VEHICLE RECALL

G-04511
September 2004

SUBJECT: SAFETY RECALL (U.S., EXPORT)
ENGINE HARNESS ROUTING on certain 9200i, 9400i, 9900i and 9900ix models built 6/2/2002 thru 1/13/2004 with Cummins ISX engines.

Figure 1

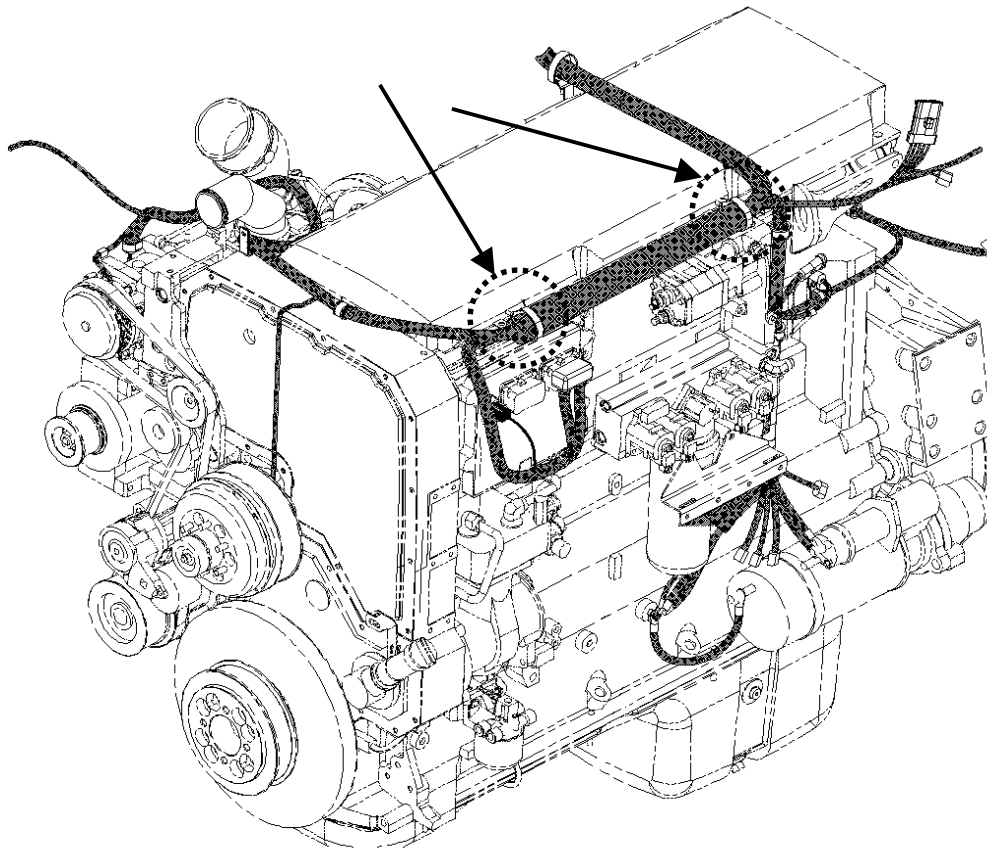
The engine electrical harness can chafe against sharp edges on the engine. A number of different failures could occur as many functions of the vehicle are processed through this harness.

1. Open and secure hood.
2. Remove existing P-Clamps from engine harness.
